IFB No.        **16-14 Auburn High School ADA Lift**

RE:        **ADDENDUM NO. 1**

Project: **Auburn High School Gym Lift and ADA Toilets**  
Project Numbers: C1741-9

**Project:** **Auburn High School Gym Lift and ADA Toilets**  
**Subject:** Addendum **No. 1**

LIFT - PLANS, ELEVATIONS AND SECTIONS

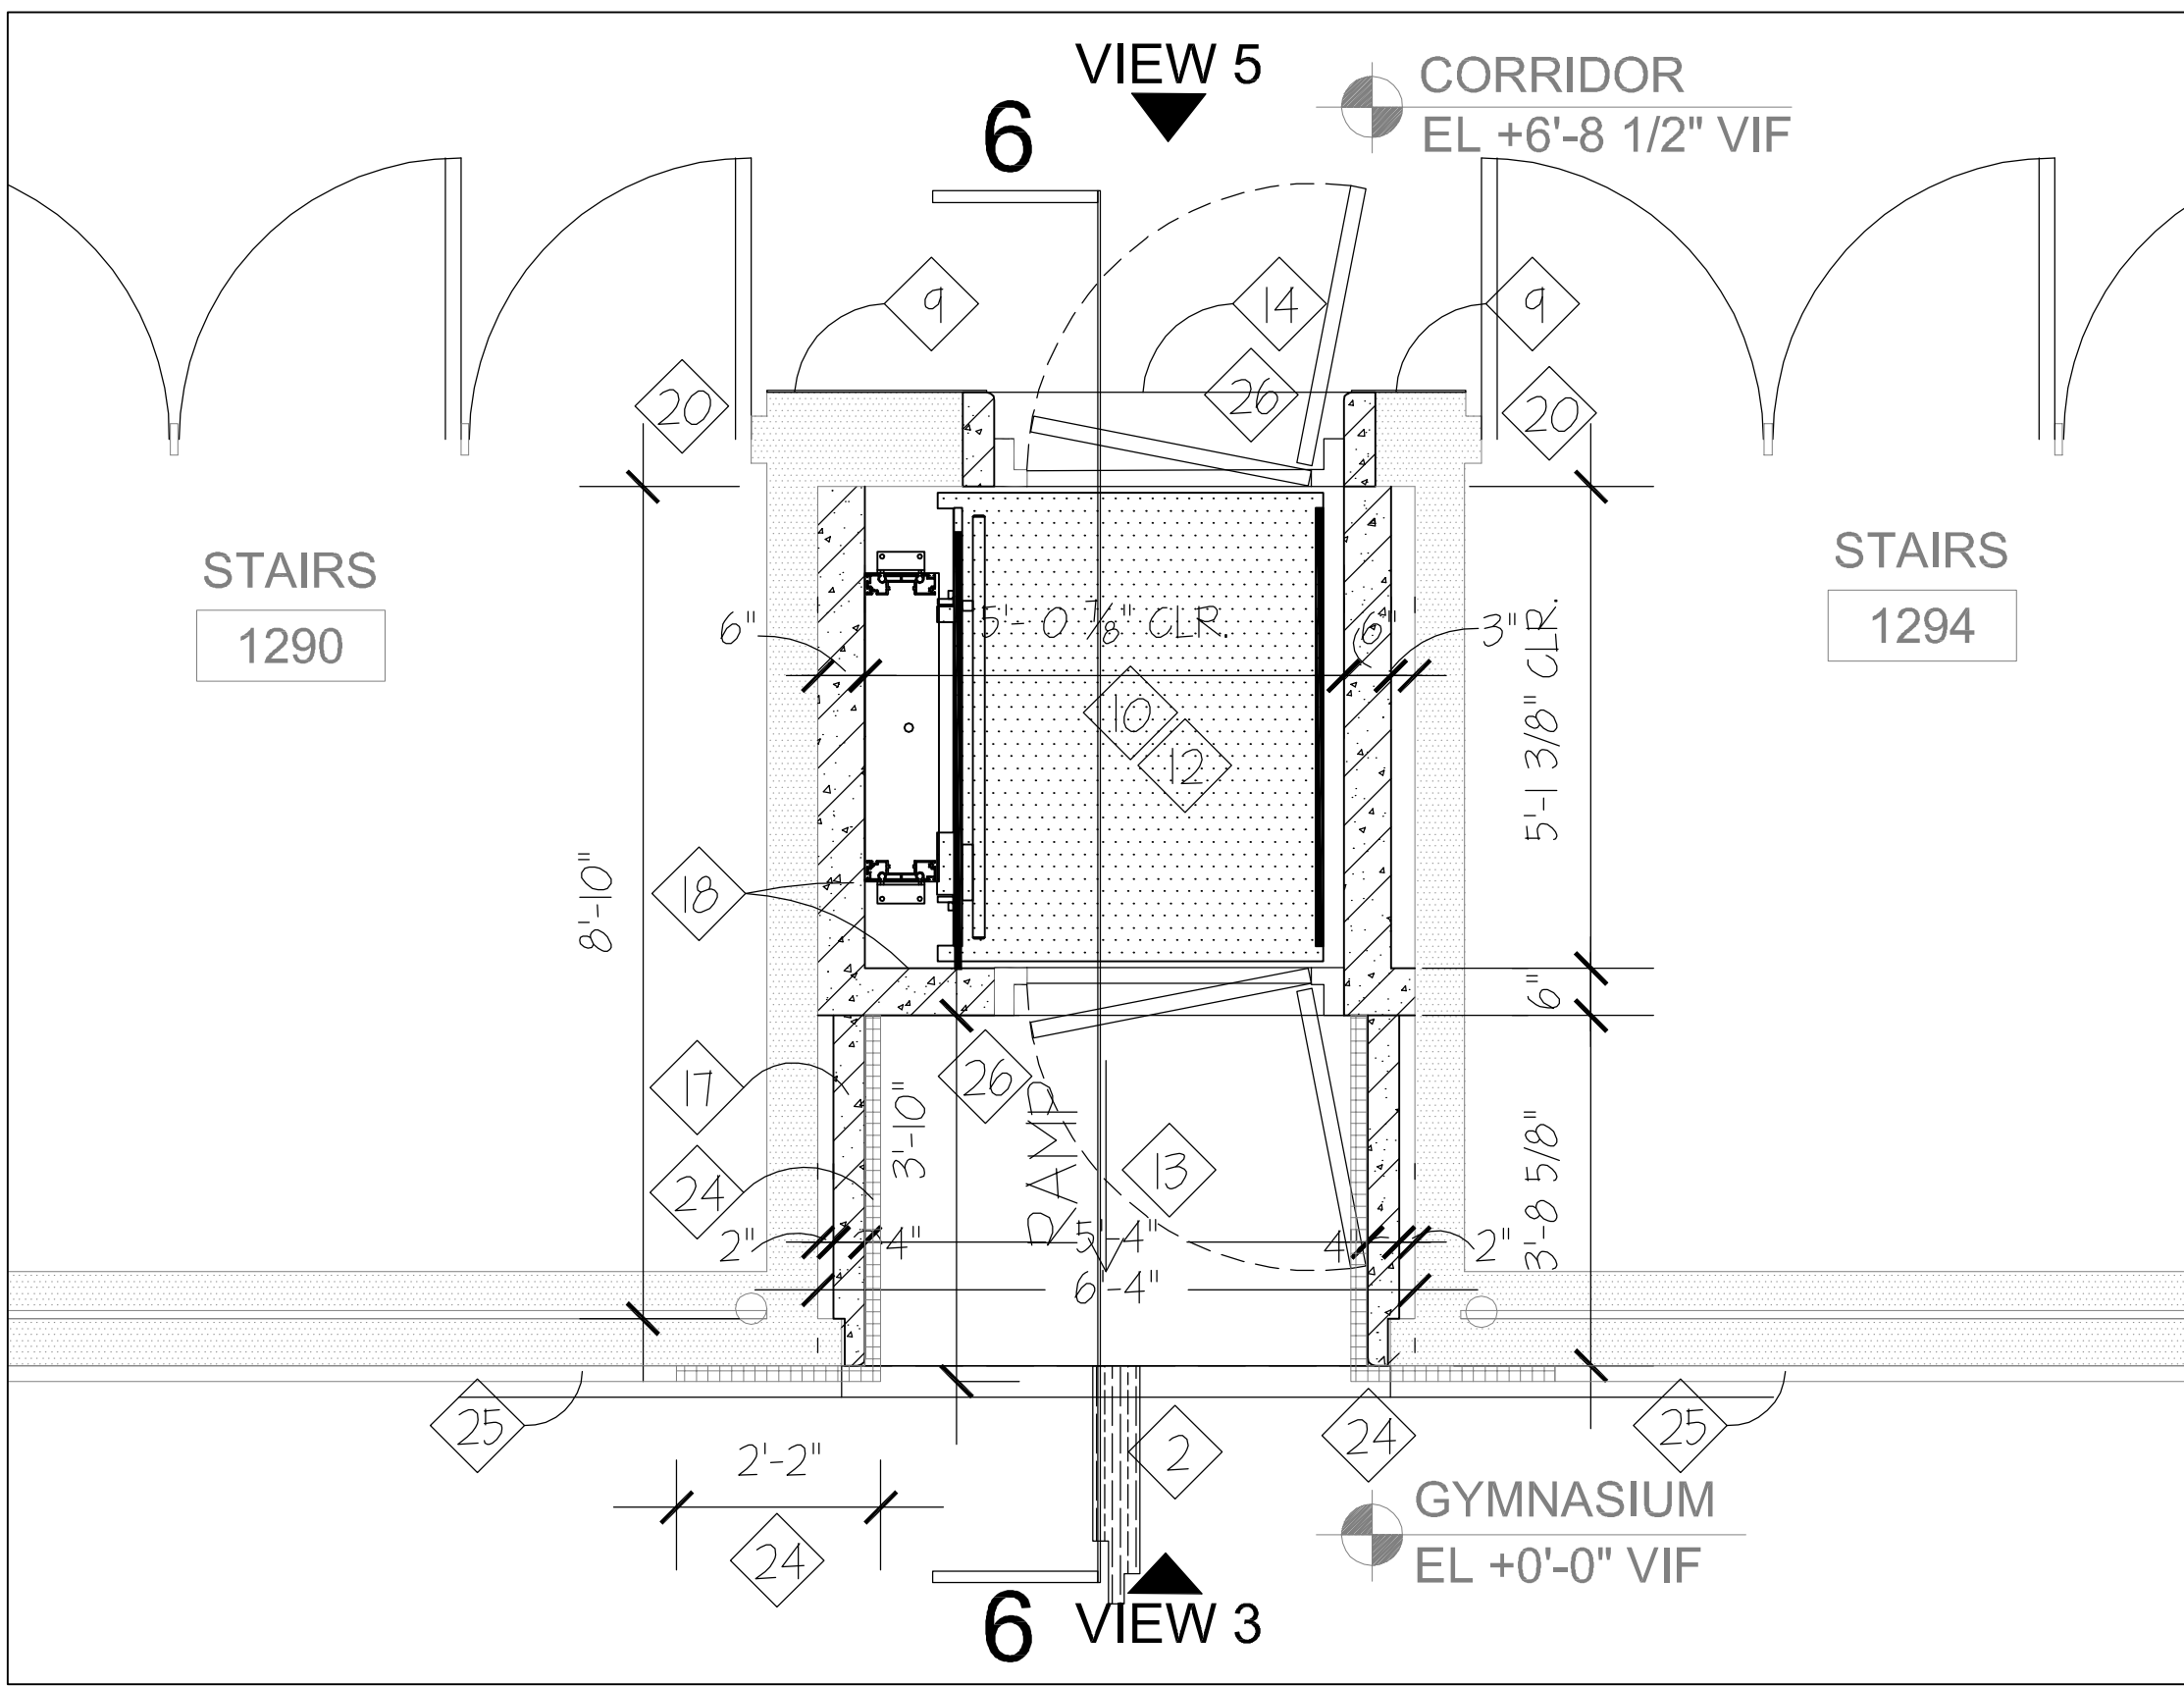
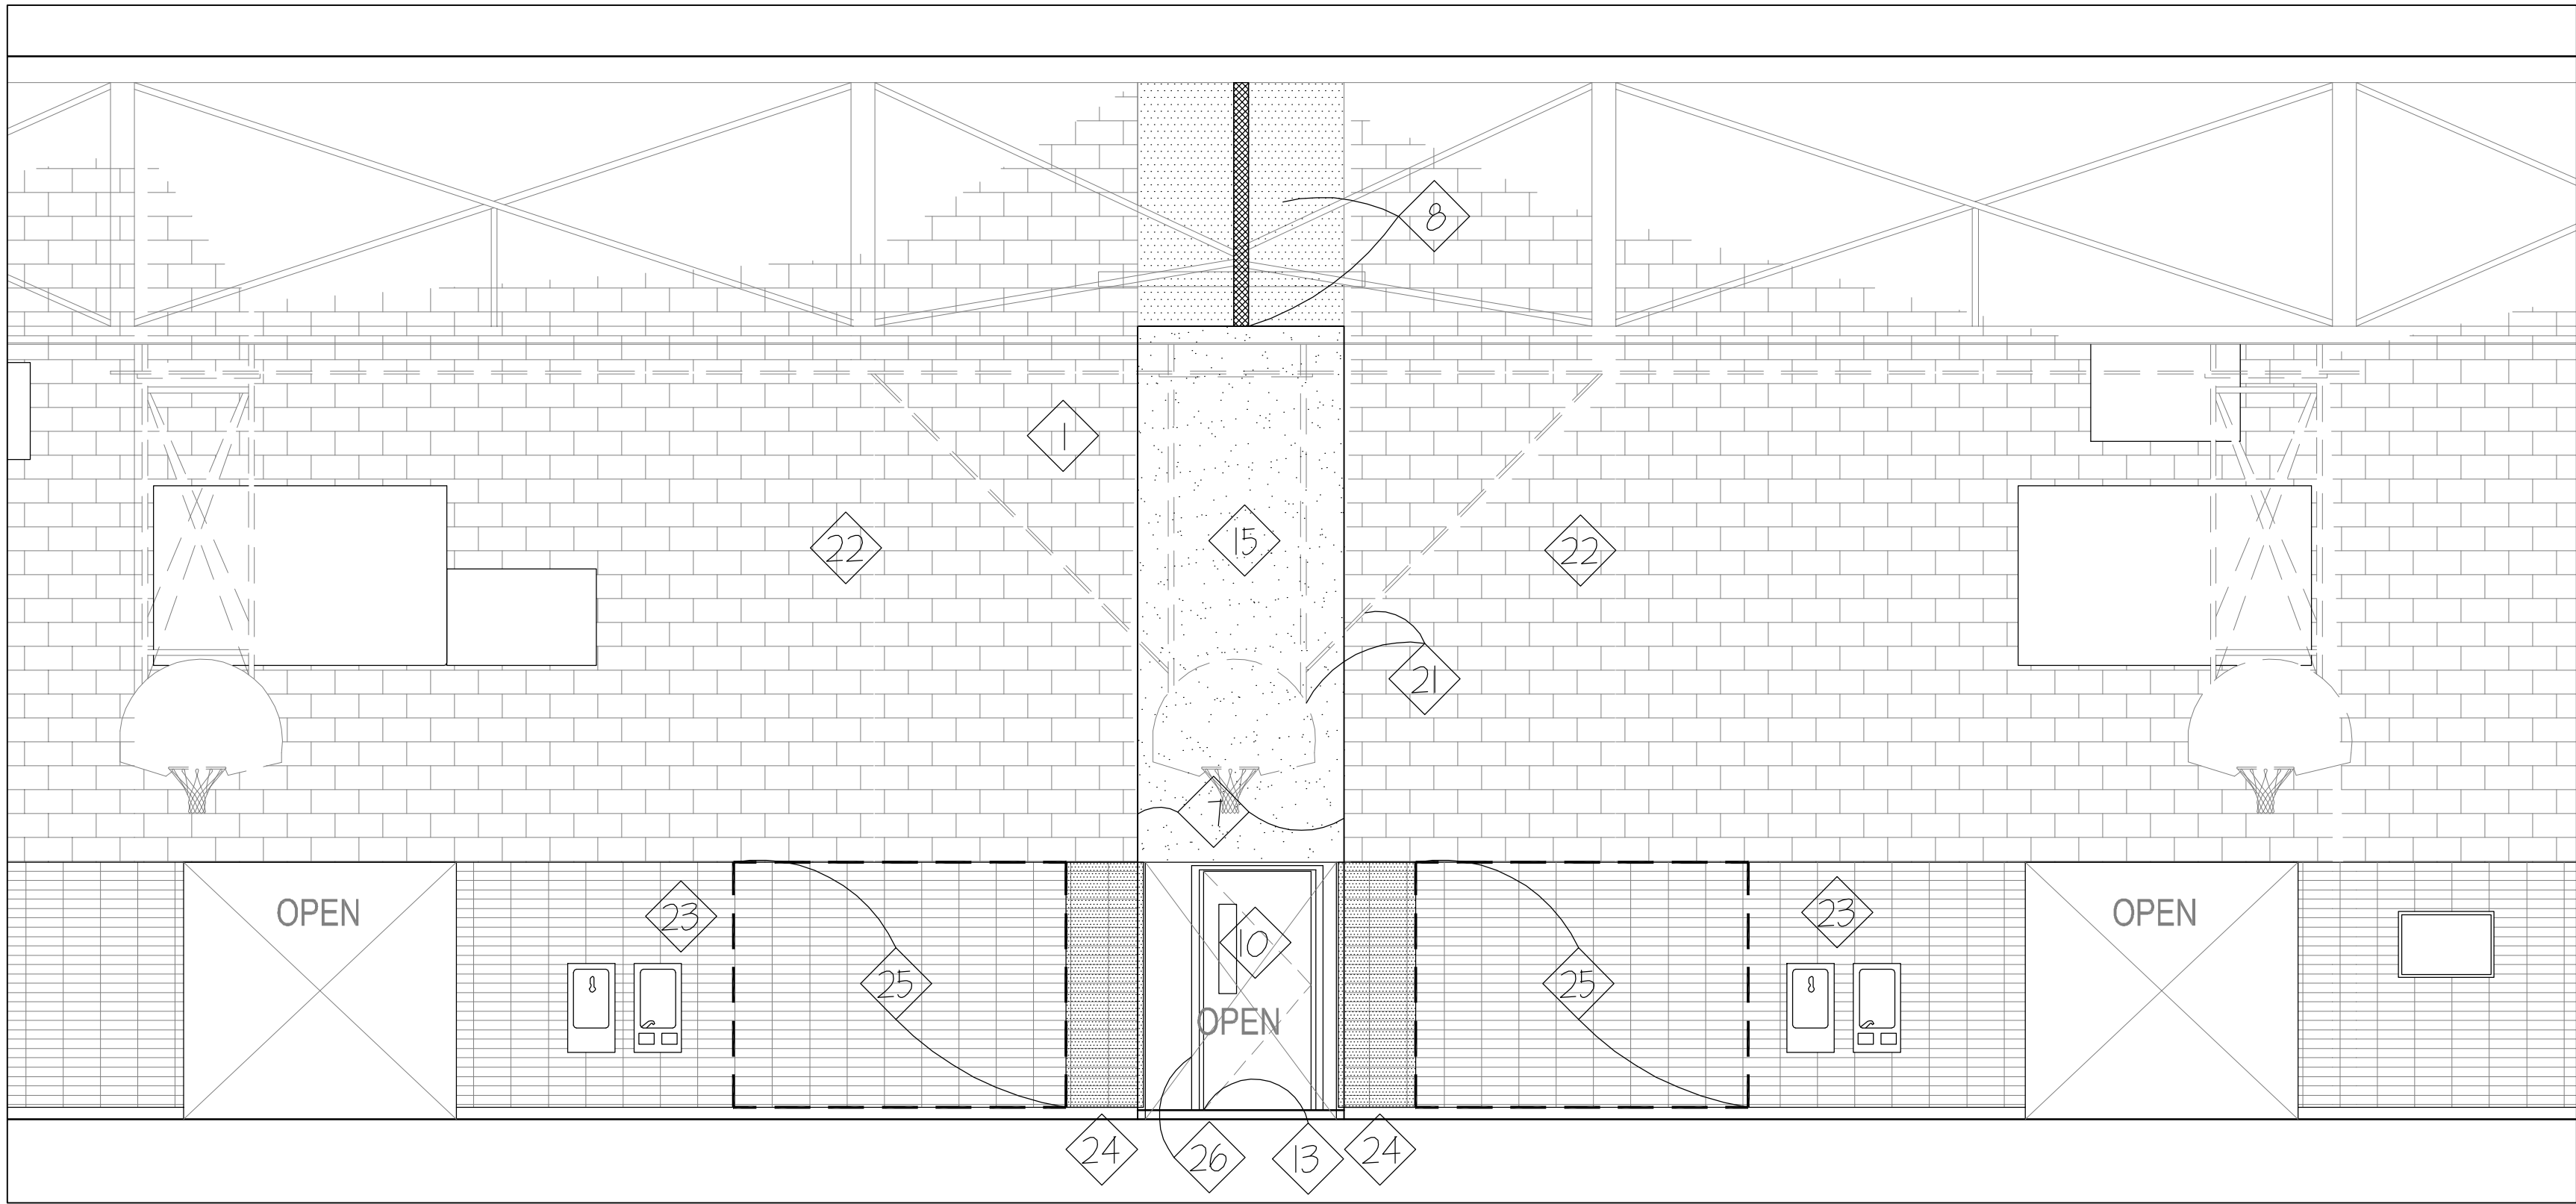
**Sheet A1.0 (Written Change Only)**

- Key Note #9: add to note- "wall tile to extend to face of lift door jamb."
- Key Note #15: replace "cement board" with "two layers of 5/8" Impact-resistant DensArmor Plus GWB or Equal"
- Key Note #17: replace "4" CMU" with "6" MTL Studs @ 16" O.C. W/ two layers of 5/8" Impact-resistant DensArmor Plus GWB or Equal- Paint, 8" above ceiling"
- Key Note #18: replace "6" CMU" (at lift door walls only) with "5" MTL Studs @ 16" O.C. W/ one layer of 5/8" Impact-resistant DensArmor Plus GWB or Equal- Paint"

3. **Q: At the Lift, drawings show CMU for the shaft enclosure. How do we account for the void between the lift doors and the rough opening required by the lift manufacturer?**

A: After discussion about coordination, or installation of the door frame first, then block in-filling around, it was decided to revise ALL the CMU construction at the **ADA Lift** to be metal stud with GWB/Impact resistant GWB. Revision will be given in ADDENDUM #1.
